**DAC 25/07/23 – 21 PARNELL PLACE NEWCASTLE EAST –
DA2022/00705 – MIXED USE - ALTERATIONS AND ADDITIONS TO
EXISTING HOTEL OR MOTEL ACCOMMODATION (NEWCASTLE
BEACH HOTEL), ANCILLARY FOOD AND DRINK PREMISES AND
COMMERCIAL USE (ANCILLARY HOTEL SPA) AND DUAL
OCCUPANCY (ATTACHED 2 X DWELLINGS)**

PARNELL PLACE

21 Parnell Place, Newcastle East, NSW 2300
LOT 1 /DP815595

DRAWING
 SHADOW DIAGRAMS -
 SHEET 2

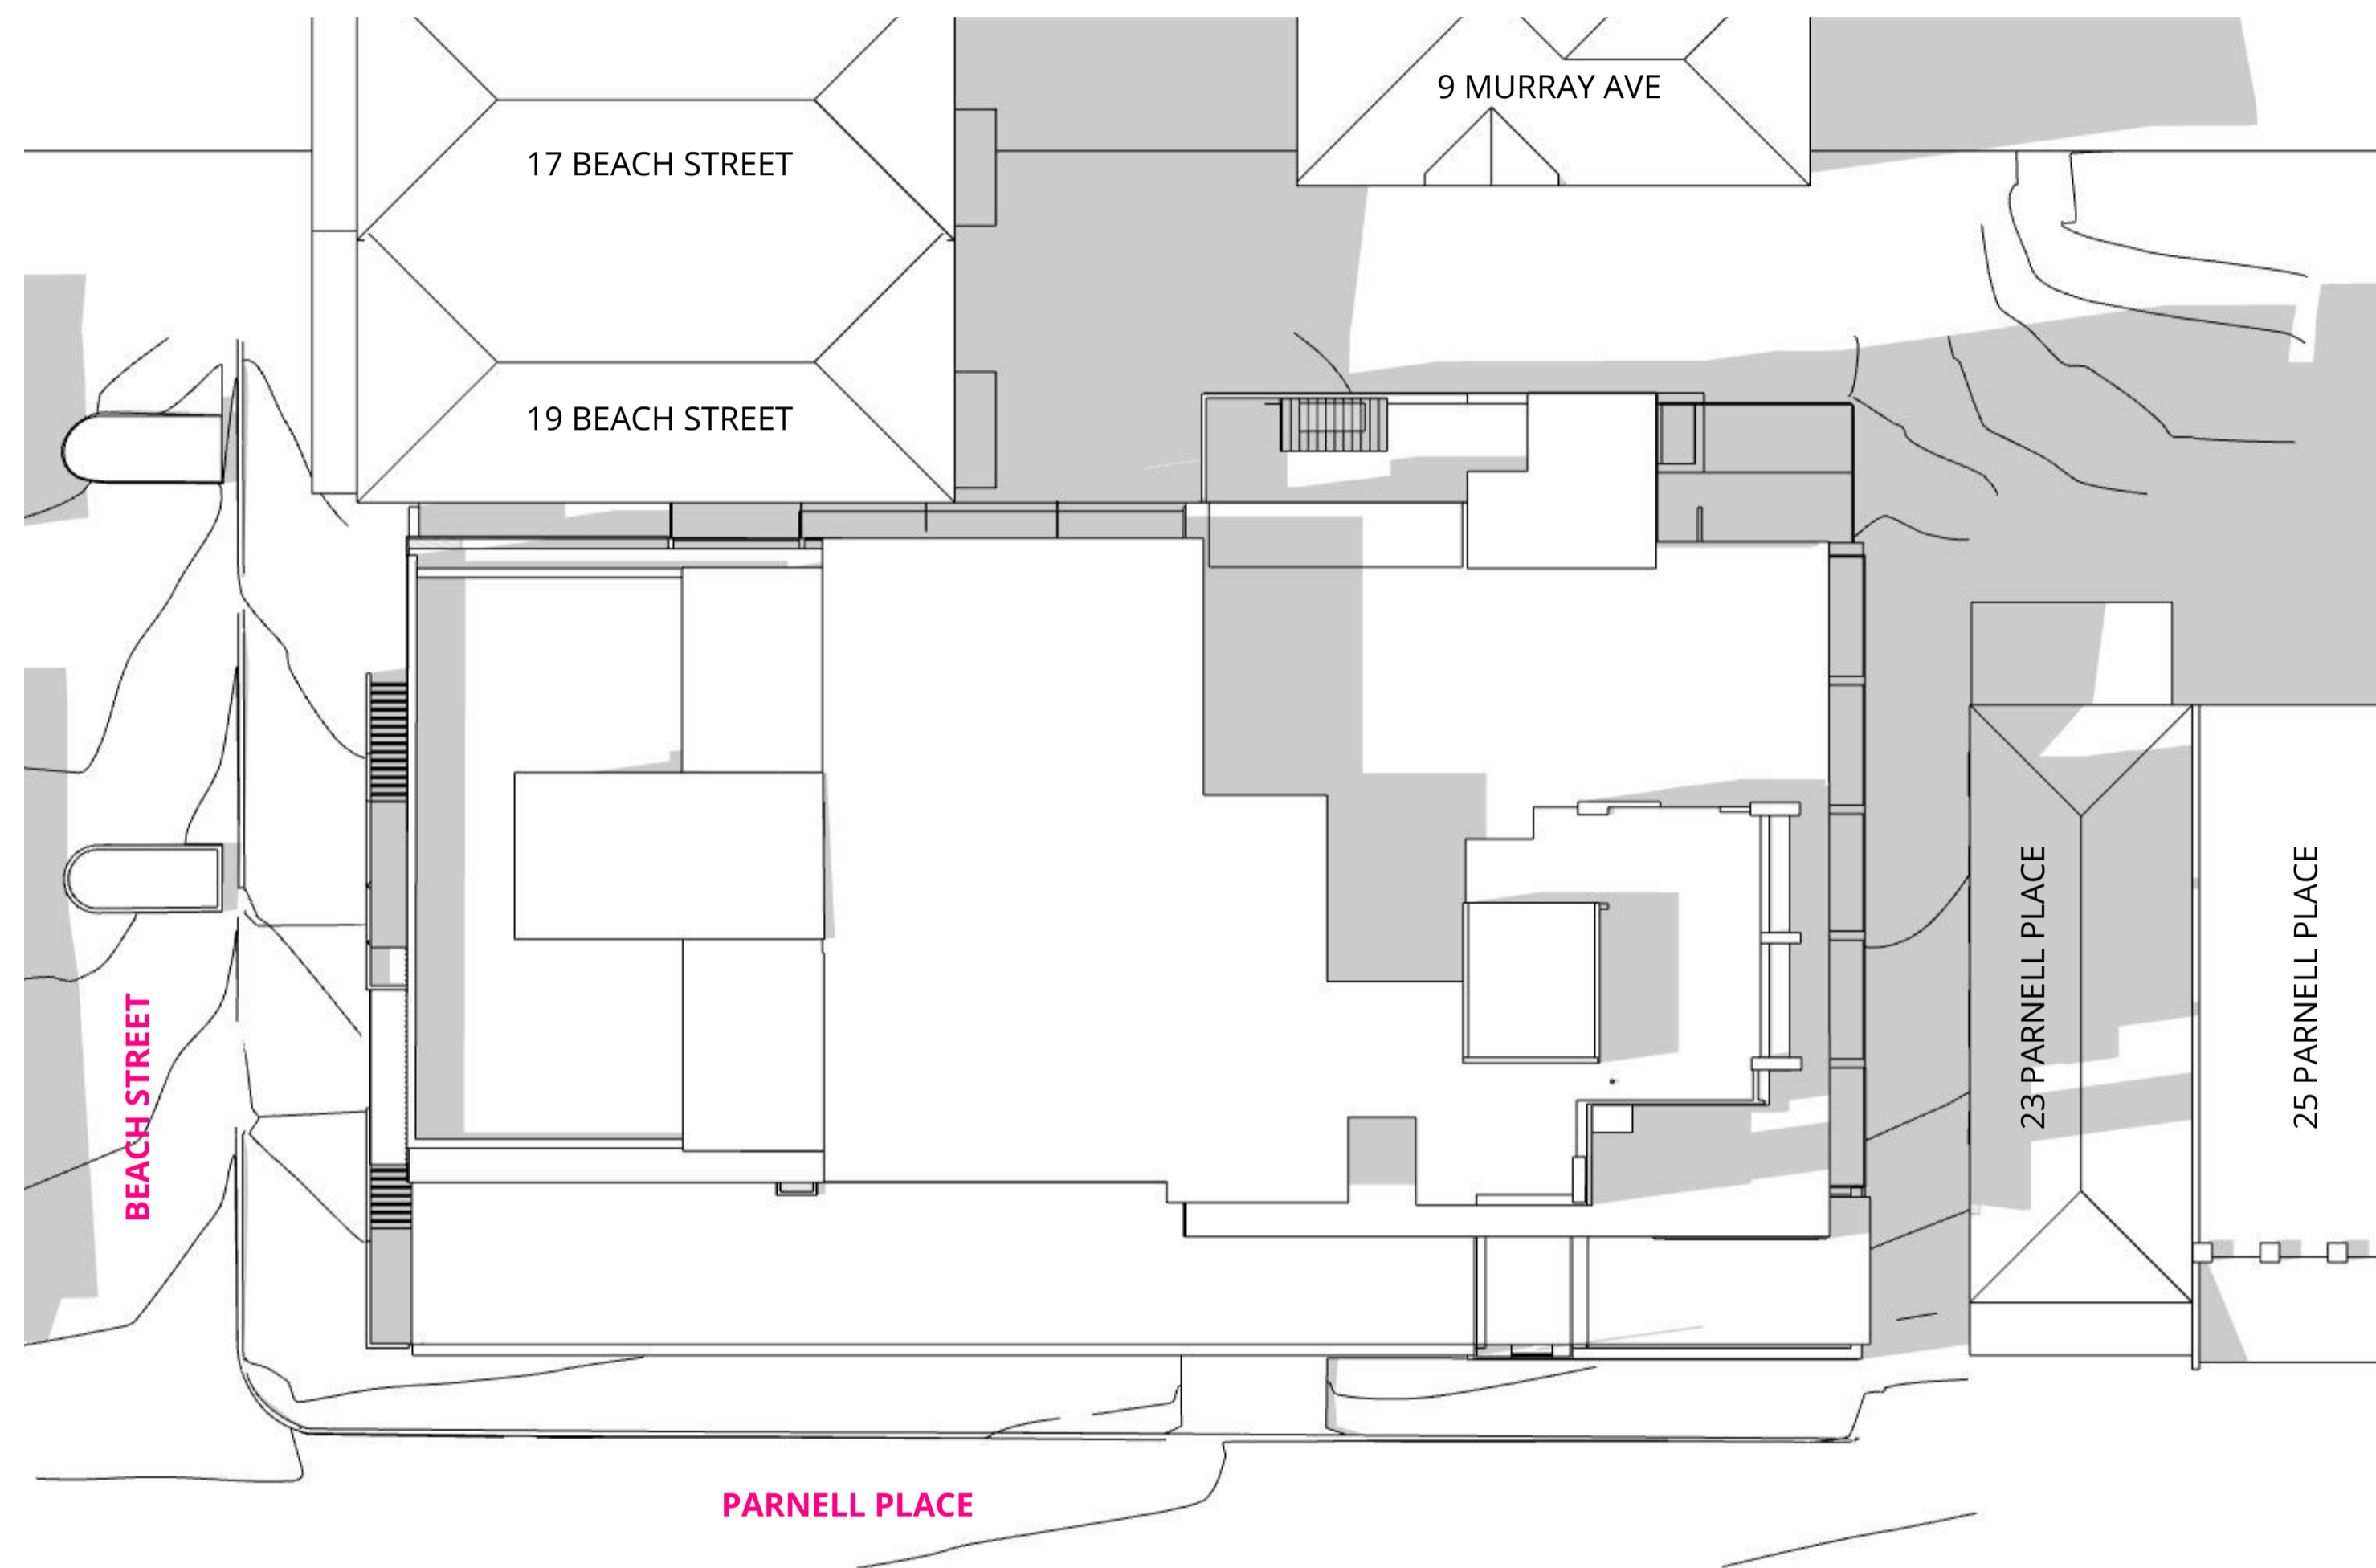
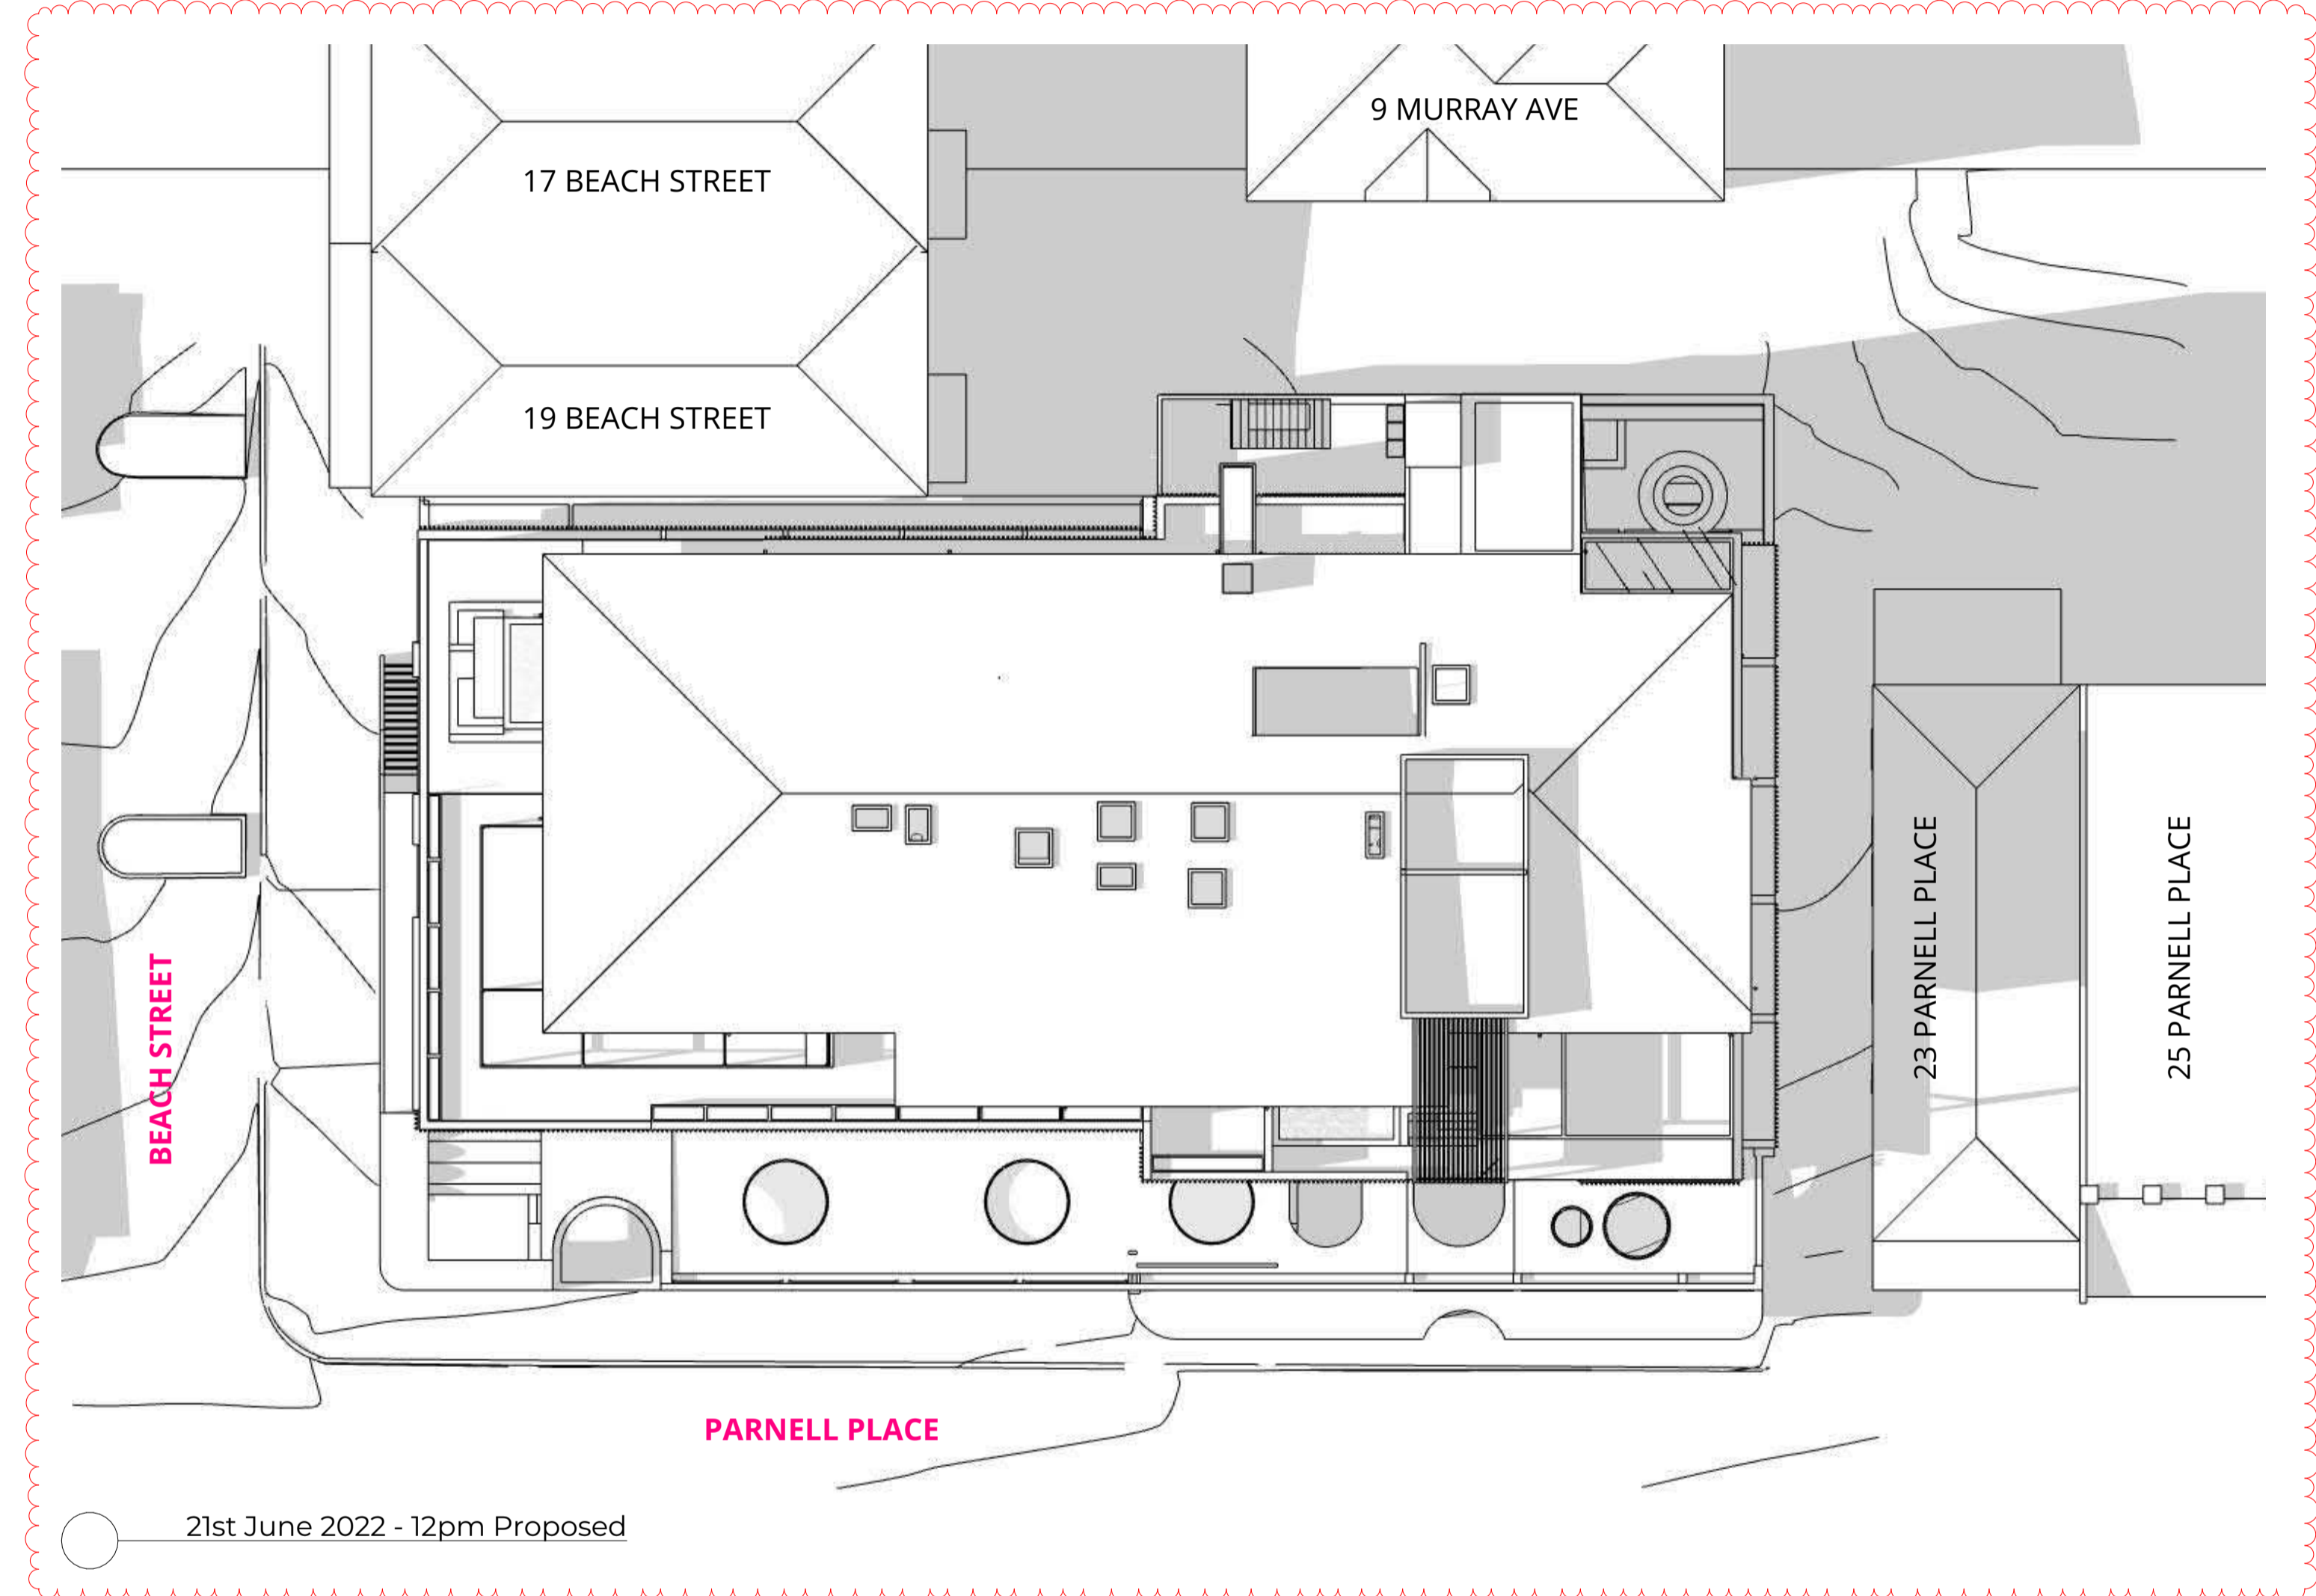
- PENTHOUSE 2 SETBACK FROM SOUTH EAST CORNER BY 1200MM AND LOW GARDEN ADDED TO SOFTEN EDGE AND REDUCE BULK & SCALE
- PENTHOUSE 2 MOVED 600MM TO WEST TO MAINTAIN FLOOR AREA
- PENTHOUSE 2 EAVE REDUCED BY 600MM TO REDUCE SCALE
- PENTHOUSE MOVED 600MM TO WEST TO MAINTAIN FLOOR AREA
- ADDITIONAL LANDSCAPING TO PENTHOUSE 01 NORTH-WEST CORNER
